Proposed restrictions for Boadicea Court

Proposed restrictions for Huntingdon Road

APPENDIX 6:

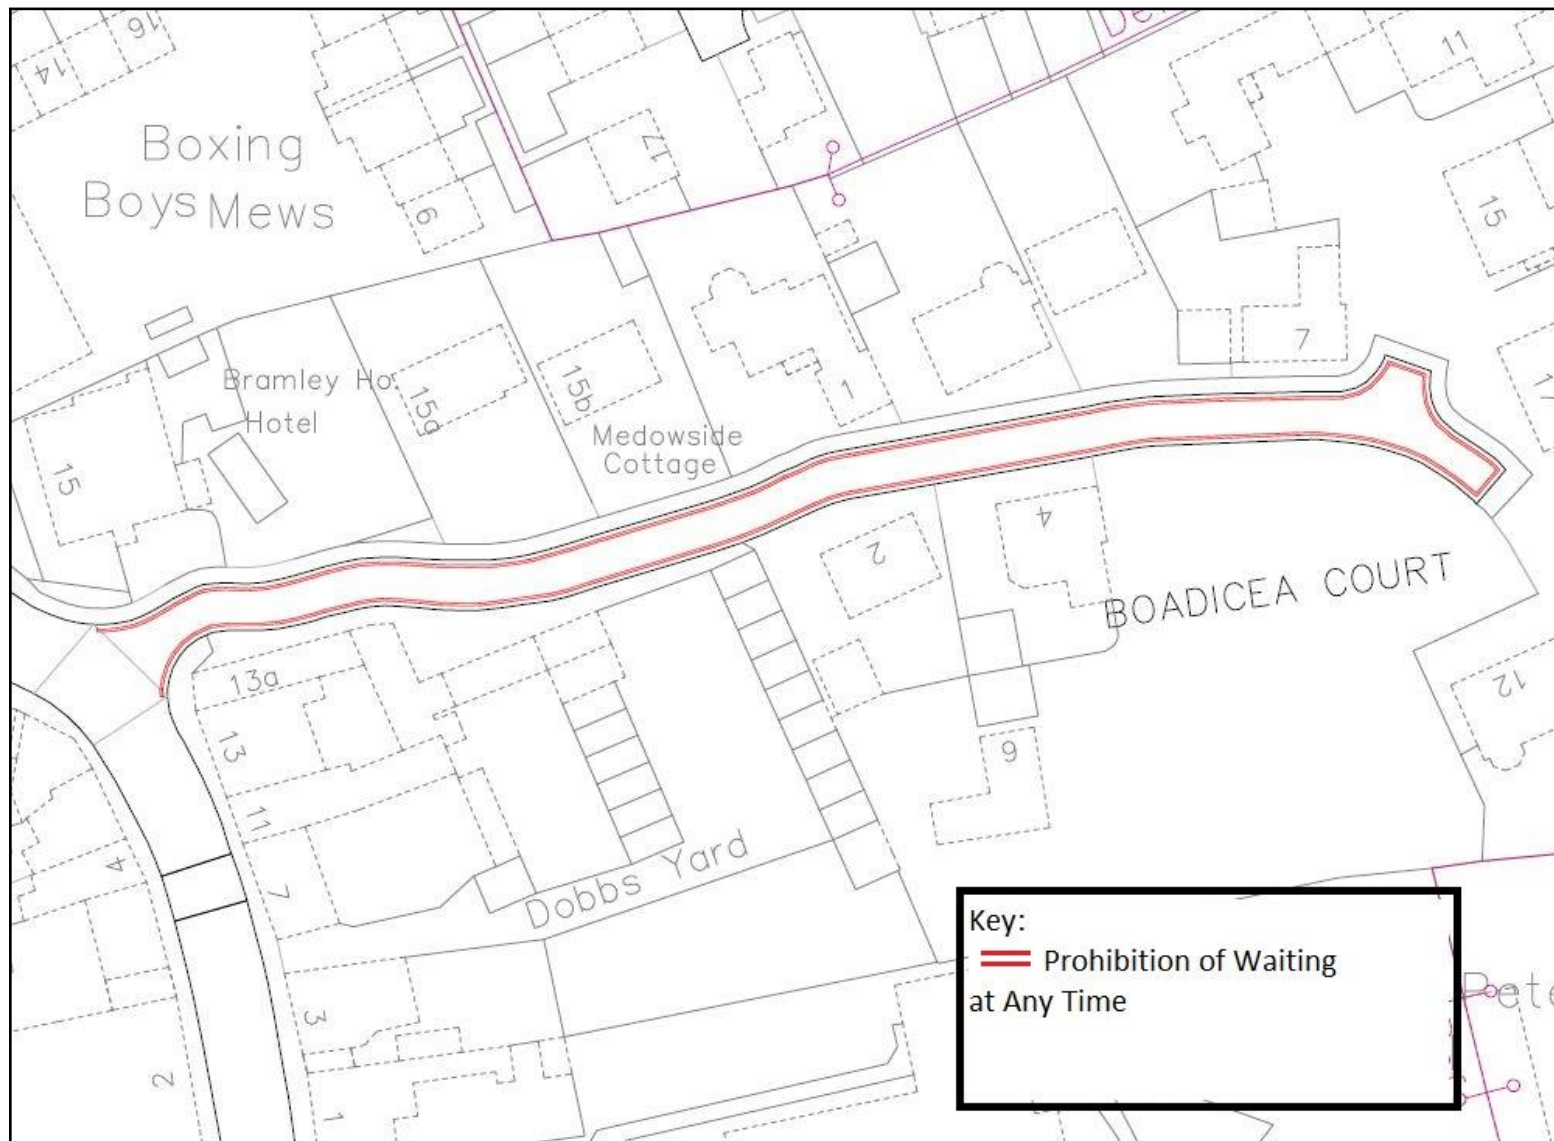
No	Objection	Officer's Comments
1	<p>I am writing to point out issues with the proposed parking restrictions in Boadicea Court.</p> <p>Firstly, I should say that the parked cars in question tend to form a continuous line along the road during working hours, less so in the evenings and weekends, so this does affect us.</p> <p>We feel that a complete ban on parking on Boadicea Court is excessive for the inconvenience occasionally of having to give way to cars coming in the opposite direction, or of parked cars being seen from the front windows of houses.</p> <p>The real problem occurs when two cars meet and cars are parked right to the very top of the road. This can involve reversing into the High Street, which is downright dangerous.</p> <p>It may be that people would get the hint that this is a bad place to park if the double yellow lines were continued round into Boadicea Court for fifteen metres or so, although it has to be said that the meaning of double yellow lines or parking on junctions are not widely understood.</p> <p>To stop parking in Boadicea Court would have a number of adverse effects: Some people in the Boadicea Court already have two cars and only two off-road parking spaces. This poses a problem for their teenage children with cars and any visitors.</p> <p>The shops opposite Boadicea Court, Pet Shop, Paper Shop etc. are by their nature "pop-in2 shops and already surrounded by no-parking</p>	<p>Noted.</p> <p>Accepted.</p> <p>Accepted. In general DYs (double yellow lines) are installed to reinforce rule 243 of the Highway Code – vehicles should not park opposite or within 10 metres of a junction. In this instance though a longer length has been proposed at the request of the applicant.</p> <p>There is a balance to be had to ensure residents and their visitors have access to some on-street parking. That said, though parking on the public highway is permitted, there is no entitlement.</p> <p>Limited waiting parking bays are present both northwards and southwards of the Pet Shop on the High Street.</p>

<p>areas will be seriously affected by another one.</p> <p>Perhaps it might be considered to extend the double yellow lines and add some restricted (say 1 hour) parking for four or five parking spaces at the High Street end of the road. This may allow the nearby businesses to continue trading.</p> <p>If the total ban on parking in Boadicea Court is to go ahead, I think some traffic calming, in the form of speed humps should be seriously considered.</p>	<p>A reduction in DYLS can be approved without the need to re-advertise, however, the introduction of limited waiting parking bays will require a secondary consultation.</p> <p>Traffic calming is expensive and is outside the scope of the project. Should restrictions be installed and residents desire the installation of traffic calming measures, they will need to contact the town council.</p>
2	<p>I write in objection to the removal of the DYLS outside No. 55 Huntingdon Road (Appendix 7) on safety grounds as parking in this location would limit visibility for the resident as they exit their driveway.</p> <p>The road is use by HGVs (heavy goods vehicles) as well as farm vehicles with the speed of traffic also being a concern.</p>	<p>The removal of DYLS has been sought to increase parking.</p> <p>Visibility is indeed obstructed but only to the left. As per rule 201 of The Highway code drivers should not reverse from a side road into a main road. To allow a safer driving conditions and minimize the effect of the house on visibility," when using a driveway reverse in and drive out."</p>
